UNITED STATES PATENT AND TRADEMARK OFFICE

APPLICATION NO.	FILING DATE	FIRST NAMED INVENTOR	ATTORNEY DOCKET NO.	CONFIRMATION NO.
09/532,786	03/22/2000	Nobuhiko Hayashi	000351	8588
23850	7590	09/02/2004	EXAMINER	
ARMSTRONG, KRATZ, QUINTOS, HANSON & BROOKS, LLP 1725 K STREET, NW SUITE 1000 WASHINGTON, DC 20006			RODRIGUEZ, ARMANDO	
			ART UNIT	PAPER NUMBER
			2828

Office Action Summary

DETAILED ACTION

FIG. 4

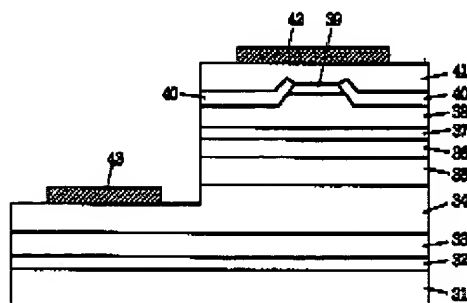
Figure 4 illustrates a nitride semiconductor laser having a nitride based semiconductor layer (32) with the composition of AlGaN, a nitride semiconductor layer (38) with the composition of AlGaN and formed into a ridge and the ridge having a width, a current blocking layer (40) formed on the side of the ridge to the top surface of the ridge, where the current blocking layers form a space on the top surface of the ridge, which has a width smaller than the width of the top surface of the ridge and a nitride semiconductor layer (39) with the composition of GaN is disposed in the space formed by the current blocking layers. See column 10 lines 15-37. Column 10 lines 42-44, discloses manufacturing the semiconductor laser by chemical vapor deposition such as (MOCVD), which is considered a transverse growth technique or process.

The current blocking layer of Kunisato et al illustrated in figure 4 has the composition of GaN or AlGa_N, as described in column 10 lines 30-31.

Figure 4 illustrates an n-type cladding layer (35), an active layer (36) and a p-type cladding layer (38) having a ridge. See column 10 lines 15-30 and lines 42-53.

The current blocking layer of Kunisato et al illustrated in figure 4 has the composition of GaN or AlGa_N, as described in column 10 lines 30-31.

Figure 4 illustrates the current blocking layer (40) having a single-layer structure.

The current blocking layer of Kunisato et al illustrated in figure 4 has the composition of GaN or AlGa_N, as described in column 10 lines 30-31.

Kunisato et al discloses forming the current blocking layers (40) on the side of the ridge (38).

Kunisato et al discloses a nitride semiconductor cap layer (39), where the cap layer is inside the opening formed on the top surface of the ridge and a nitride semiconductor contact layer (41), which is in contact with the cap layer, and where both layers have the composition of p-type GaN and provide an electrical contact between the electrode (42) and the ridge.

Kunisato et al does illustrate in figure 4 an electrode (42), as described in column 10 lines 38-40.

Figure 4 Kunisato et al illustrates the current blocking layer (40) having a single-layer structure with the composition of GaN or AlGaN, as described in column 10 lines 30-31.
